SUBJECT: NuScale Power, LLC Supplemental Response to NRC Request for Additional Information No. 196 (eRAI No. 9050) on the NuScale Design Certification Application

NuScale Supplemental Response to NRC Request for Additional Information eRAI No. 9050

NRC Question No.: 16-18

Figure 7.1-1k: ESFAS - Containment System Isolation, Chemical and Volume Control System Interlocks

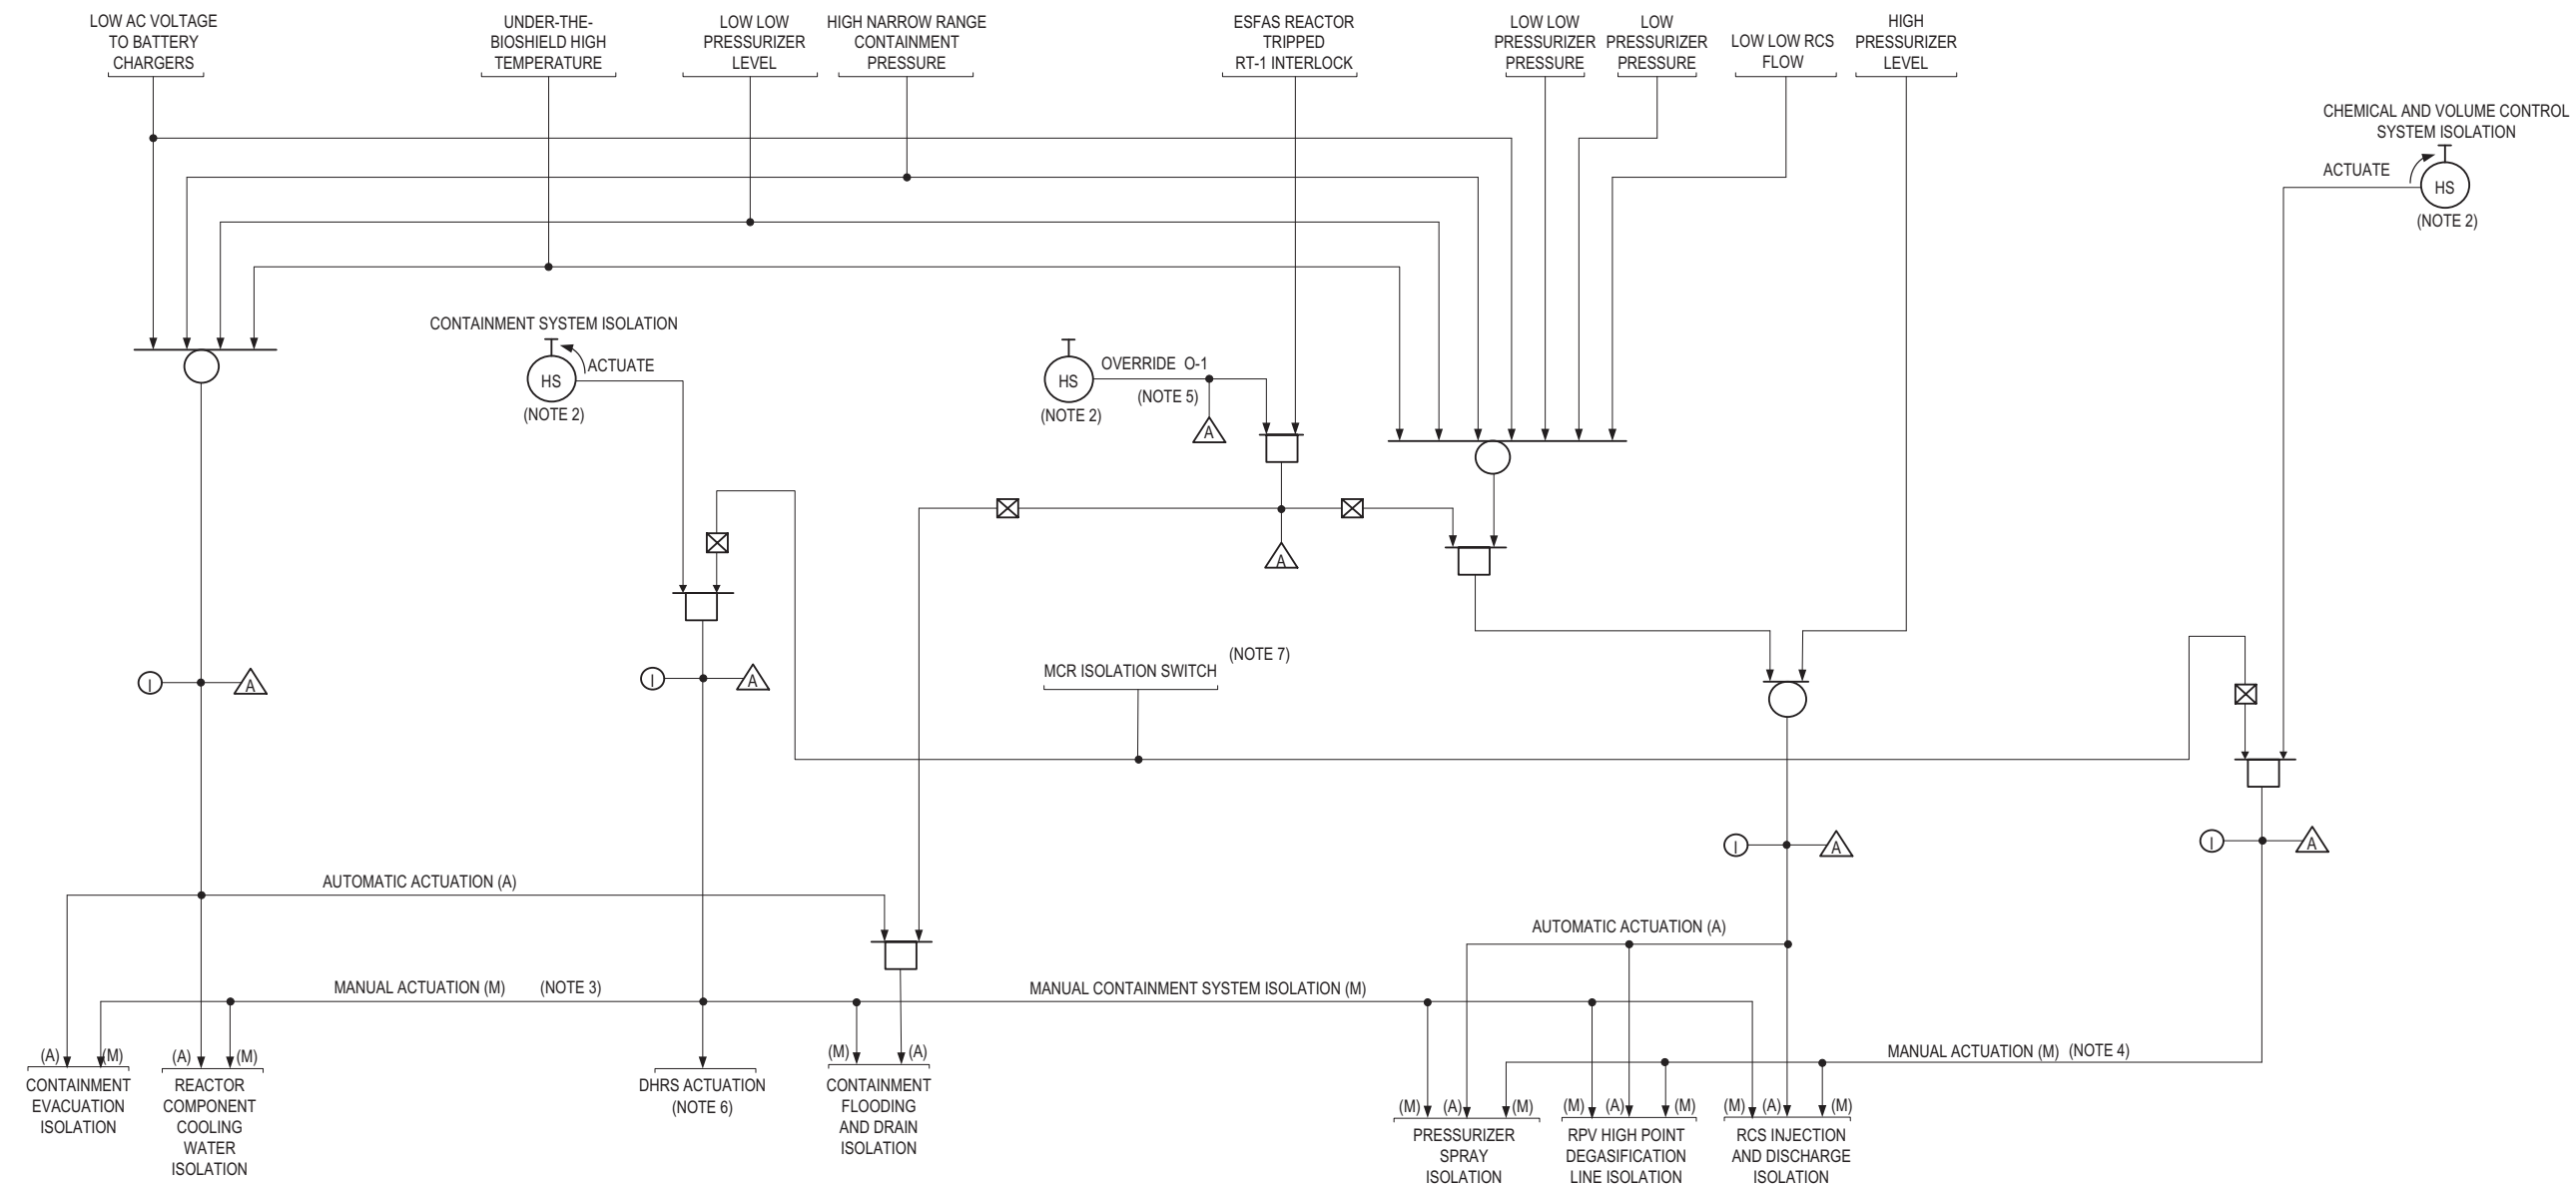
A description of the O-1 override is added to the Bases of LCO 3.3.1. The override applies to

portions of the MPS and actuations described in LCO 3.3.3, however no additional changes are proposed because those Bases refer to the description provided in the Bases for LCO 3.3.1. Additionally, some changes were made to Chapter 7, "Instrumentation and Controls," Table 7.1-5, "Module Protection System Interlocks / Permissives / Overrides," and Figure 7.1-1k, "ESFAS - Containment System Isolation, Chemical and Volume Control System Interlocks," of the FSAR to describe the design and function of the O-1 override.

NOTE 5: OVERRIDE TO ALLOW OPERATORS ADD WATER TO CONTAINMENT DURING CONTAINMENT ISOLATION.
